**AGENDA FOR A MEETING OF THE PLANNING AUTHORITY COMMITTEE OF  
DEVONPORT CITY COUNCIL HELD ON MONDAY 17 JULY 2017  
AT THE COUNCIL CHAMBERS AT 5:00PM**

4.1 PA2017.0055 Residential (Multiple Dwellings x 5 to be used for the purposes of Supported Accommodation for Disabled Persons) - Assessment against the performance criteria for provisions including 10.4.1, 10.4.2, 10.4.3 and Traffic Generating Use and Parking Code (Lesser than Permitted Number of Parking Spaces) - 35 Dana Drive Devonport ( <b>D480397</b> ) .....	4

4.2 PA2017.0084 Residential (Single Dwelling) - Assessment against the Performance Criteria for Building outside of the Permitted Building Envelope - 116-118 North Street Devonport ( <b>D480915</b> ) .....	30

4.3 PA2017.0081 Residential (Shed) - Assessment against Performance Criteria for Setbacks and Building Envelope - 31 Swilkin Drive Spreyton ( <b>D480948</b> ) .....	63
<b>5.0 CLOSURE .....</b>	<b>88</b>

Figure 2 – Proposed multiple dwelling development plans – 35 Dana Drive, Devonport  
(Source: DCC – PA2017.0055)

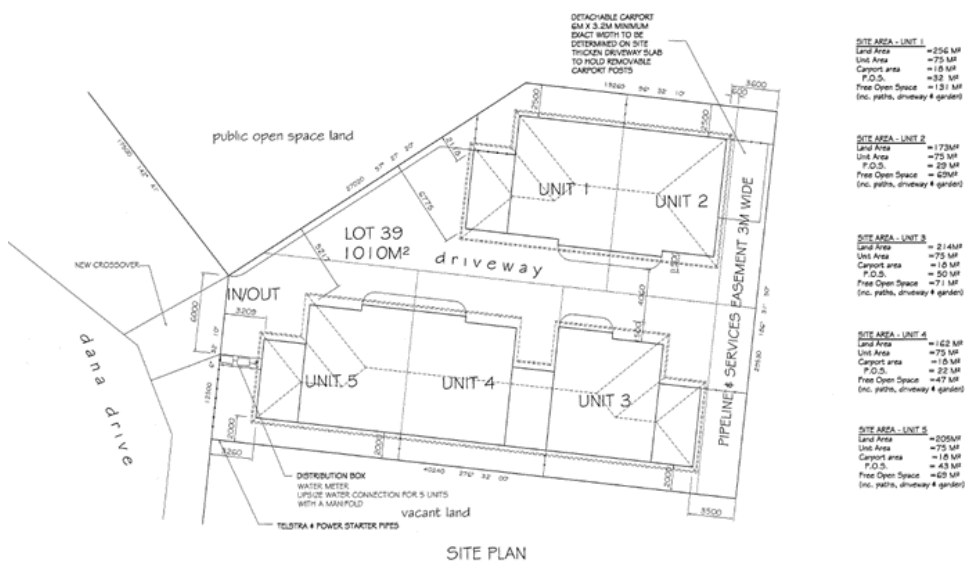
The discretion to allow a lesser than permitted site area per dwelling (325m<sup>2</sup> being the permitted standard and 202m<sup>2</sup> representing that sought) would appear to have a flow on effect to the other applicable development standards of the planning scheme. In other words, the number of dwellings proposed for the site impacts on the ability to comply with the permitted standards relating to building setback, the allocation of private open space, and available area for parking and vehicle turning/manoeuvrability within the site.

2. The developer is to submit a design drawing of the proposed driveways, accesses and car parking for approval prior to any works commencing. The car park layout is to comply with Australian Standard *AS/NZS 2890.1 (2004) – Parking Facilities – Off Street Car Parking*. All design drawings are to be submitted as part of any subsequent building permit application and include turning paths for access and egress for all proposed parking sites including 300mm clearance as per AS2890.1 Appendix B.

LANDSCAPING PLAN

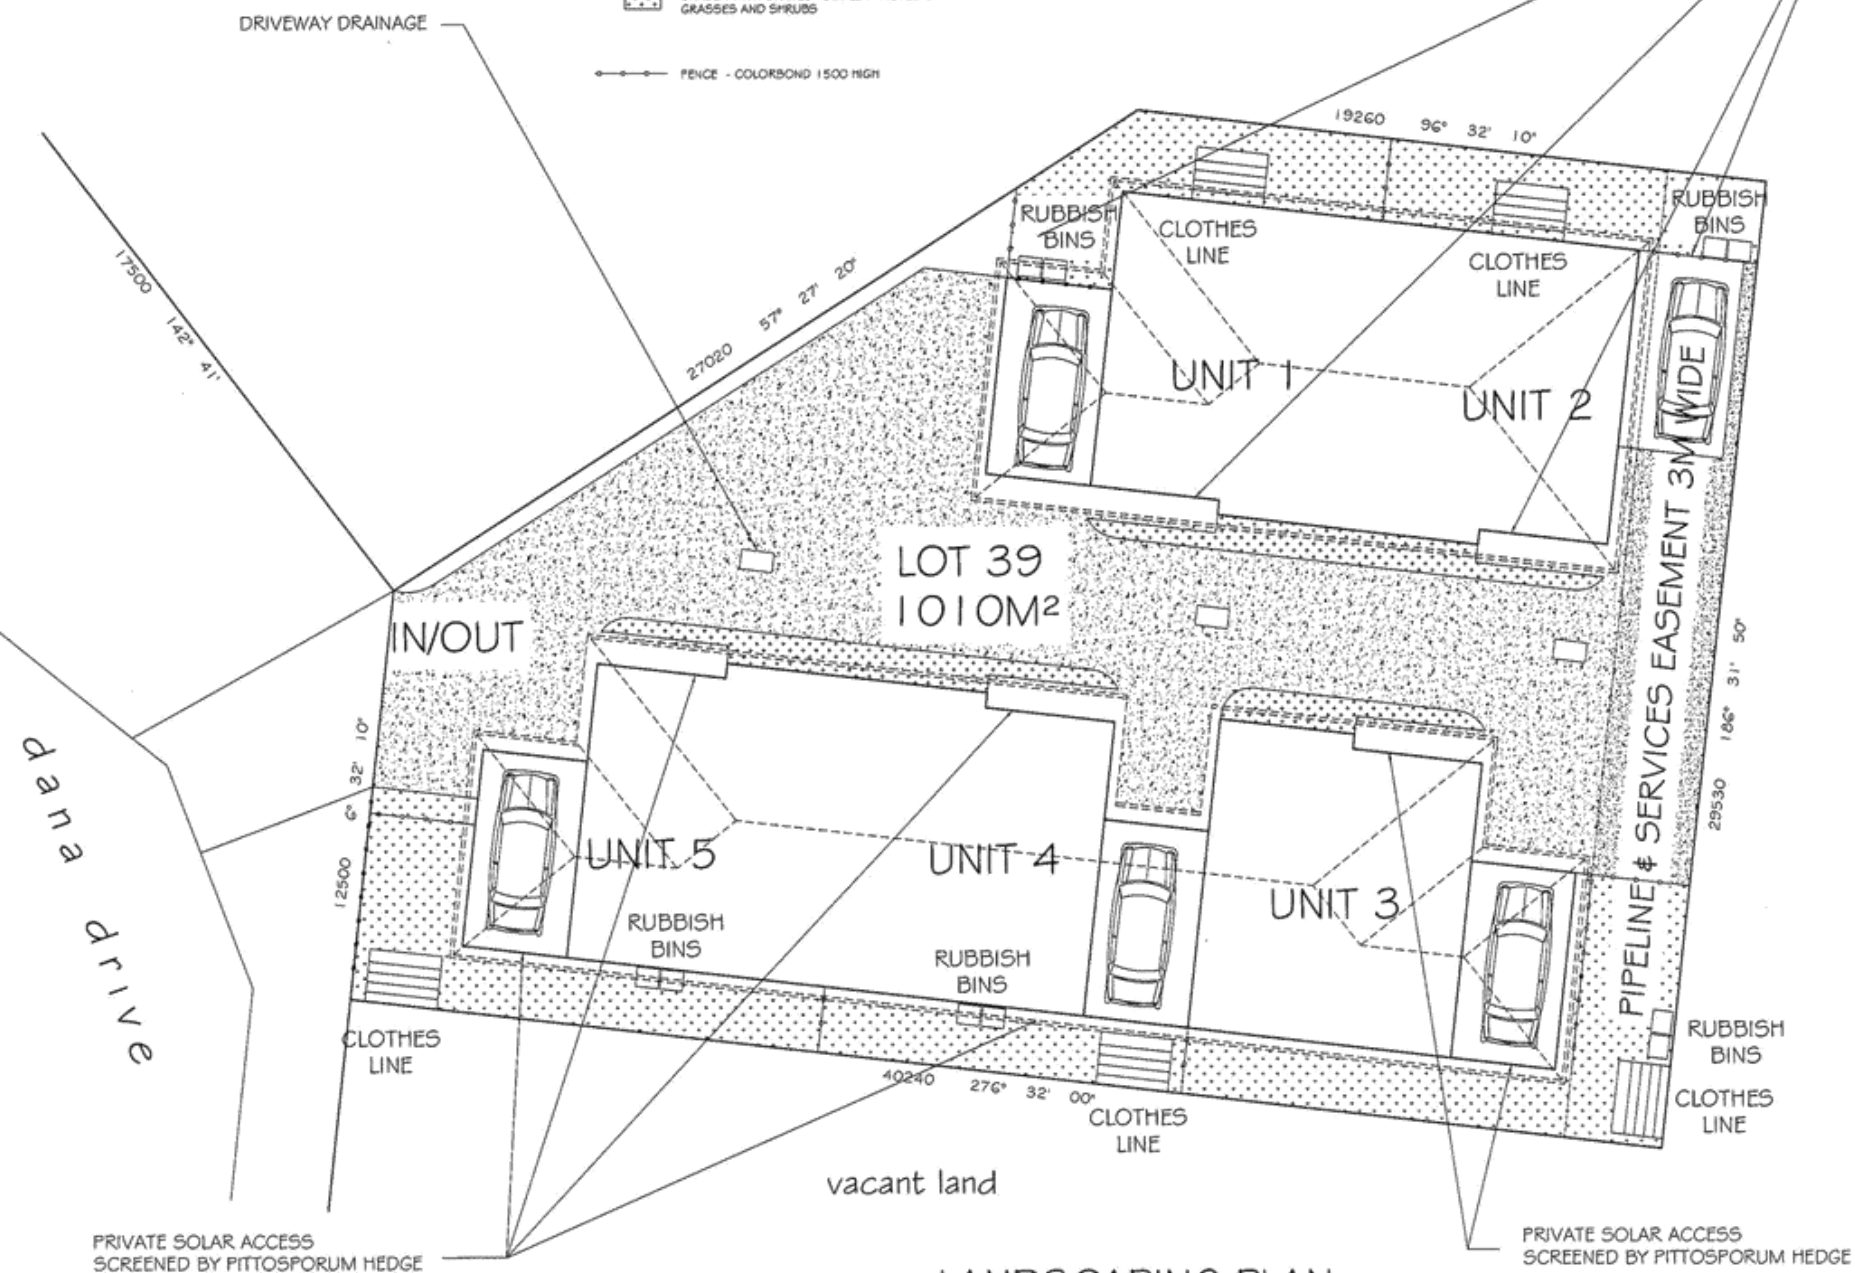
<p>The corresponding Performance Criteria is generally framed on the basis that an appropriate level of screening is provided for the shared driveway or the driveway is otherwise located or designed so as to minimize unreasonable detrimental impact (noise, light intrusion).</p> <p>The detail submitted with the application shows a separation of less than 2.5m from the shared driveway to the doors/windows of habitable rooms of the dwellings and there is no provision of screening nominated. Accordingly there is not sufficient detail provided to determine that the requirements of the PC are satisfied.</p>	<p>movements. The parking areas are to the side of each dwelling, the central driveway running east/west in the centre of the property.</p> <p>Plantings of pittosperum to screen windows are indicated on Drawing 3.</p>

Figure 4 – Proposed single dwelling development plans – 116-118 North Street, Devonport – CT73838/34  
(Source: DCC – PA2017.0084).

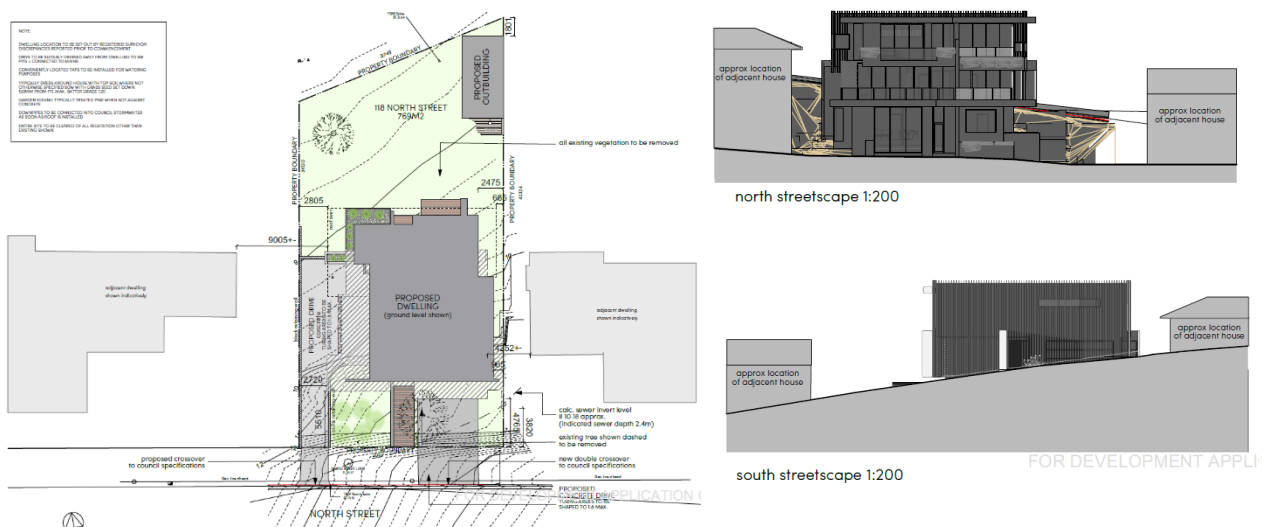
The site is zoned General Residential under the DIPS and the development standards for this Zone include the provision of a permitted building envelope<sup>7</sup> within which dwellings are to be contained. The building envelope as required by provision 10.4.2 A3(a) is reproduced in Figure 5 below and can be described as follows:

Figure 2 - Copy of Site Plan submitted by applicant with location of outbuilding circled in red

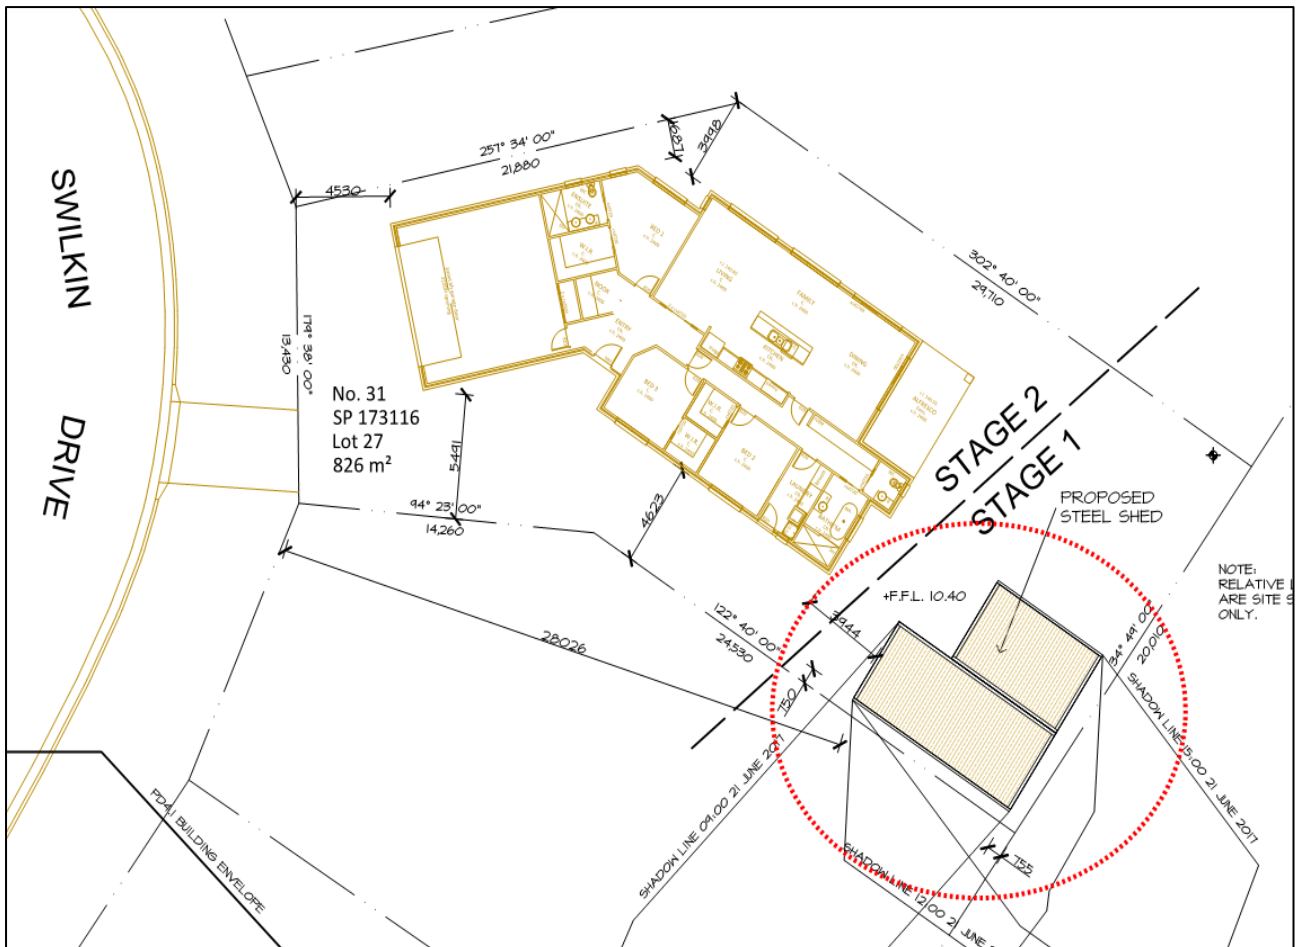
In this case the shed fails to satisfy the Acceptable Solutions for development standard 10.4.2 (A3) - *Setbacks and building envelope for all dwellings*. This is due to the shed being located within the minimum rear setback threshold of 4m (0.75m rear setback proposed). Furthermore, because the shed fails to meet the rear setback requirement it also falls outside the prescribed 3-dimensional building envelope which is applicable to all types of development within the General Residential zone. For information purposes, the 3-dimensional building envelope is reproduced as Figure 3.

Figure 5 – Shadow diagram of the shed provided by the applicant

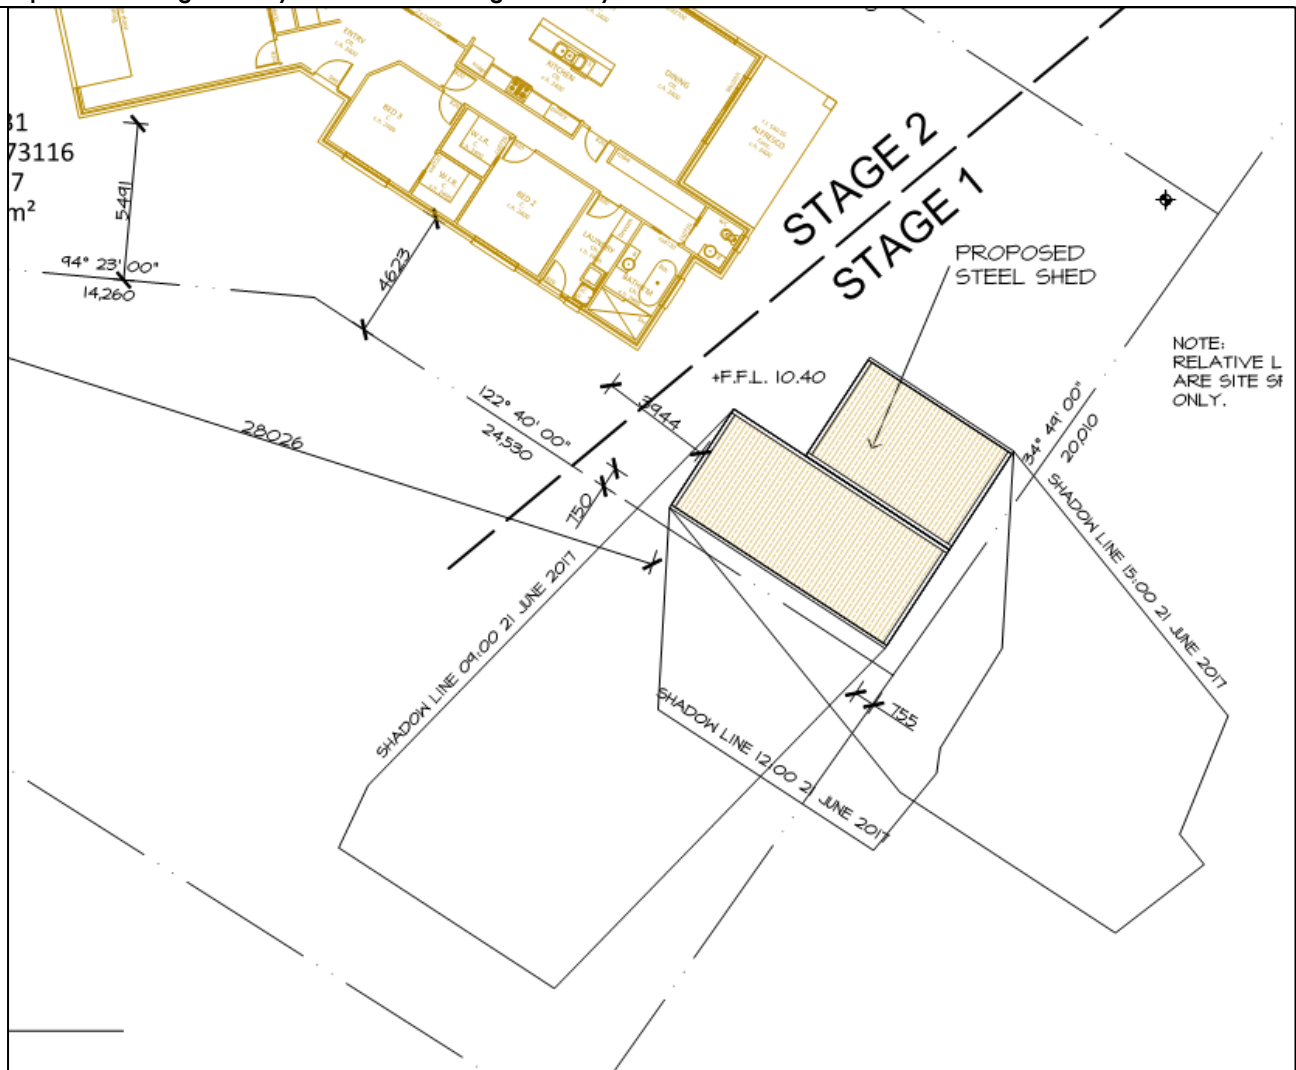
The shadow diagram has been examined and it is found to be a true reflection of the shadow cast from the proposed shed. It is evident that the neighbouring residential lot to the south (33 Swilkin Drive) will be burdened by overshadowing from the shed during morning hours. However, it needs to be considered if the overshadowing impact is 'unreasonable'. After being on-site it is considered the overshadowing impact from the shed is not unreasonable. From approximately 12 noon the overshadowing effect from the proposal will be negligible and afternoon sunlight will be available in the areas subject to overshadowing in the morning. In addition, any overshadowing impact to habitable rooms for a future dwelling at 33 Swilkin Drive is considered minimal due to the location of the proposed shed and the likelihood of a dwelling to be positioned within the central region of the lot.

It is also interesting to note that if the shed was setback 4m from the rear boundary (not taking into consideration the future house design) the shed would have complied with the Acceptable Solutions and therefore could be assessed as 'No Planning Permit Required'. This is because the Acceptable Solutions allow a development such as an outbuilding to be constructed to a side boundary if the wall length is less than 9m and the proposal can fit within the prescribed 3-dimensional building envelope (refer to Figure 3). It is acknowledged that if the shed was setback at a minimum of 4m to the rear boundary it would have a greater impact to the southern adjoining lot in regard to overshadowing

Figure 6 - Approximate location of future house at 33 Swilkin Drive with the inclusion of the overshadowing diagram from the proposed shed

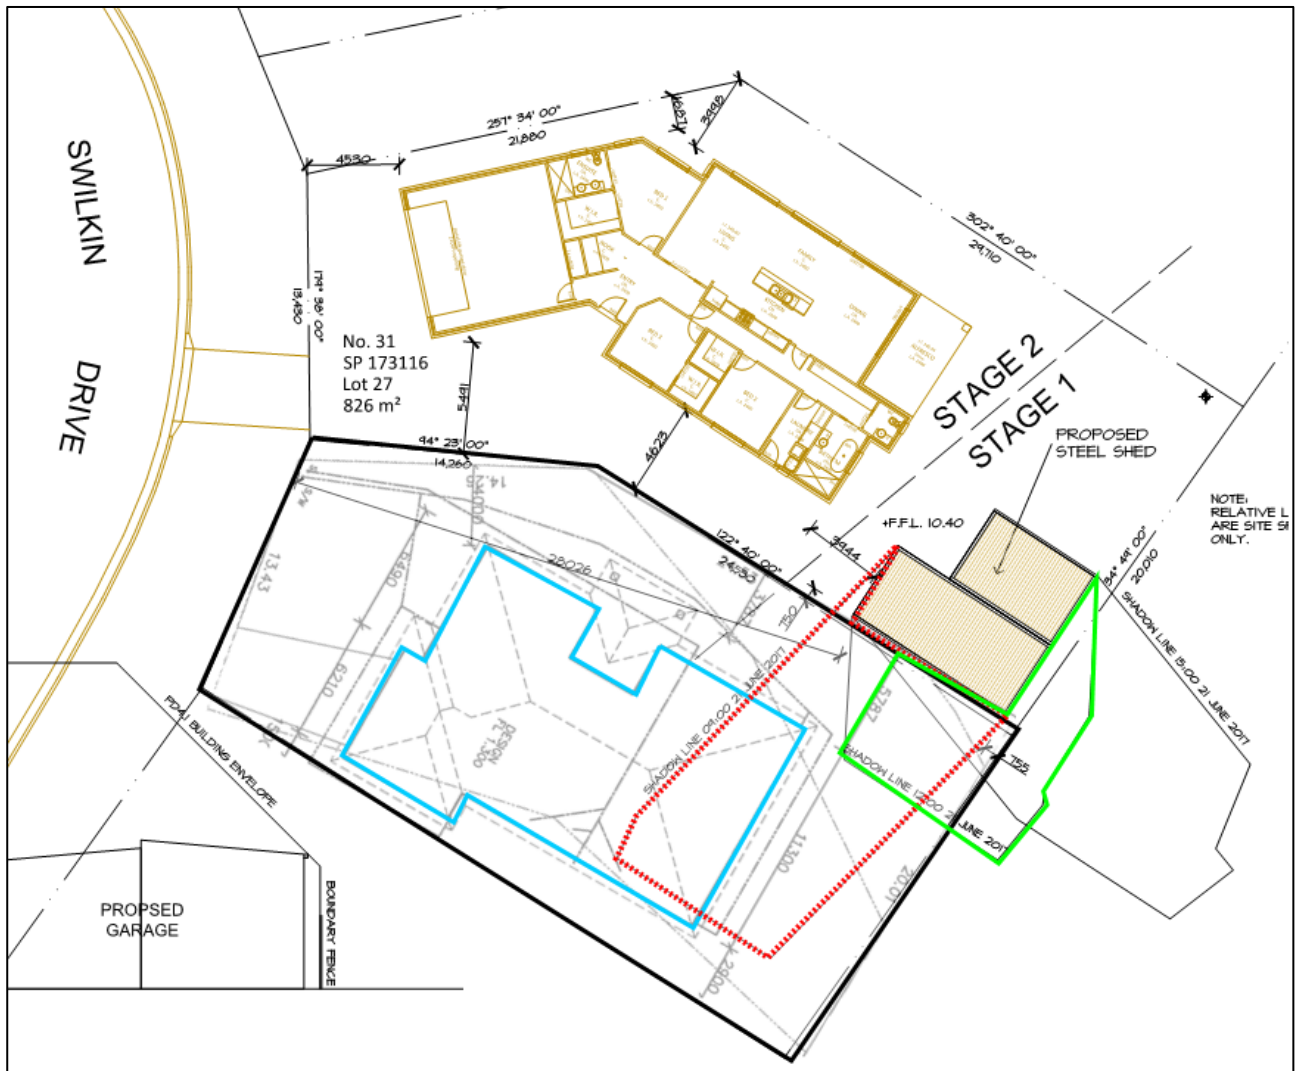
Figure 6 demonstrates that the shed will overshadow the rear section of the dwelling at 33 Swilkin Drive particularly during the early morning. Ironically, however, as discussed within the *Planning Issues* section of the report, the overshadowing impact would be a lot more detrimental if the shed was located 4m in from the rear boundary and yet a planning permit would not be required. The overshadowing impact has been tested against the applicable Performance Criteria and it has been found the shed has merit to be approved. No further commentary is warranted regarding this matter.
